Piedmont Community Club

Transition Plan - (location/priority)

Piedmont Community Club
Lower Level
City of Duluth, MN

Piedmont Community Club
 Upper Level
 City of Duluth, MN

Photo 1: View of upper level entry. Maneuvering clearance is not currently provided at the main door due to the angle of the wall.

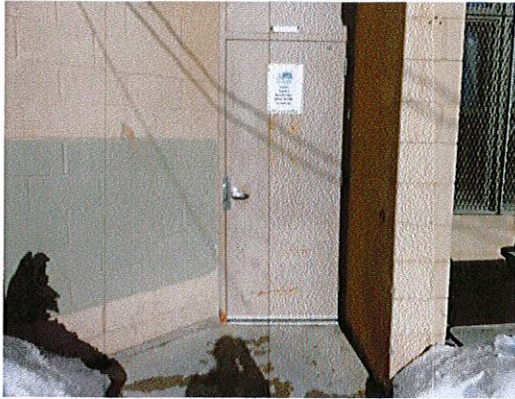
Main Entry- Upper Level									
12C 16179	Relocate door and frame to provide an appropriate approach to the door. ICC / ANSI 404.2.3.1 <i>Photo 1.</i>	1	\$1,500	\$1,500	3

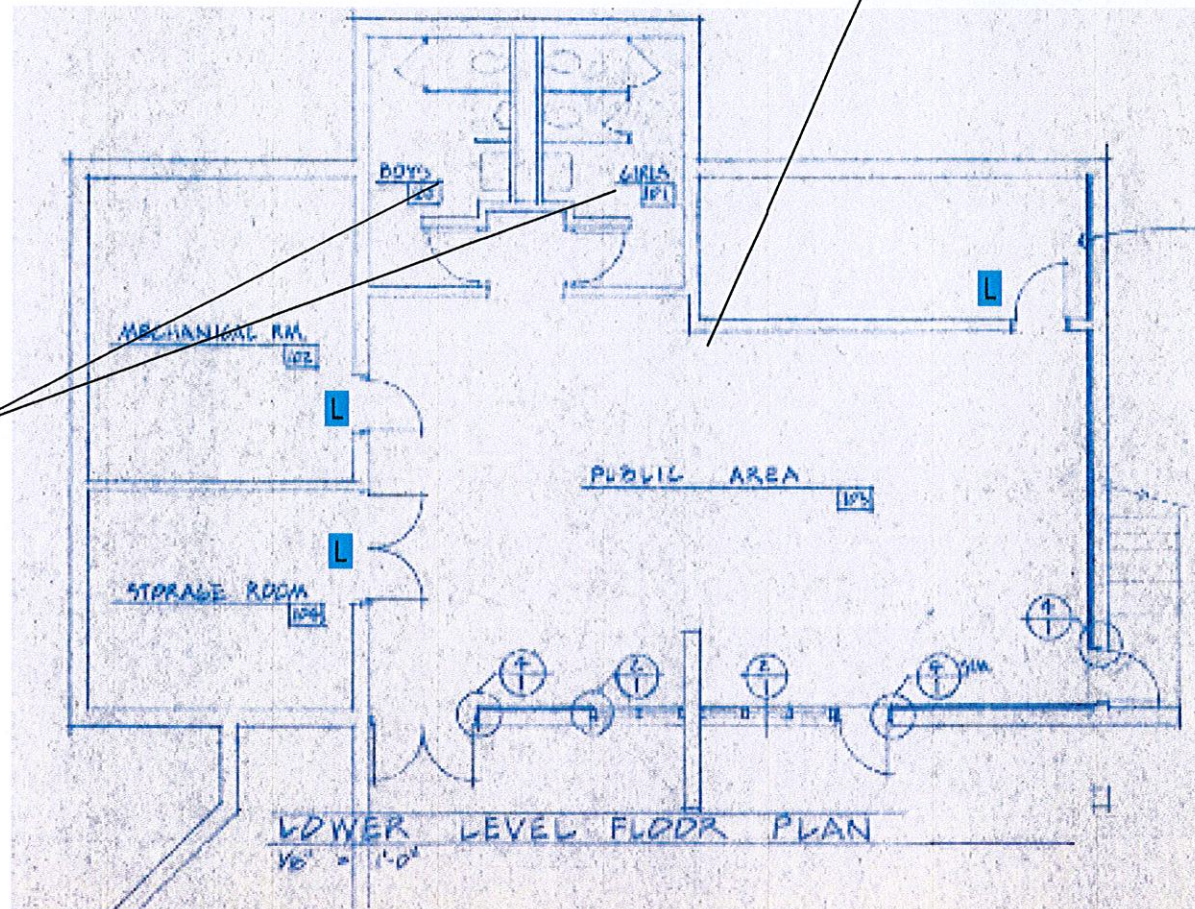
Eliminate protruding hazard at heater

Add raised and braille sign
Insulate pipes at lavatory
Replace faucet
Add full height mirror
Lower the towel dispenser
Add pull to accessible stall door
Replace grab bars

Create an accessible route

Install door lever hardware

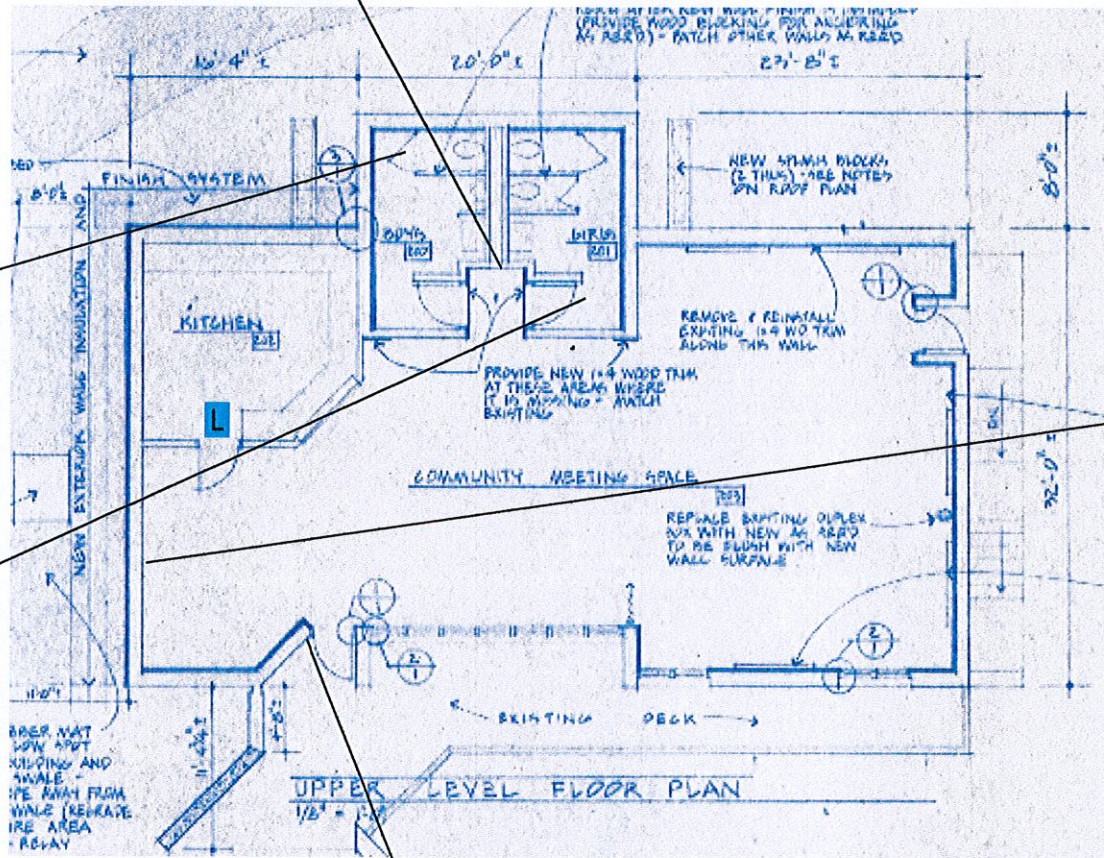
Relocate drinking fountain

Add raised and braille sign
 Insulate pipes at lavatory
 Replace faucet
 Add full height mirror
 Lower the towel dispenser
 Add pull to accessible stall door

Add raised and braille sign
 Insulate pipes at lavatory
 Replace faucet
 Add full height mirror
 Lower the towel dispenser
 Add pull to accessible stall door

Replace rotary dial phone

Modify entry to provide maneuvering clearance

Parking
 Designate an accessible parking space

L Install door lever hardware
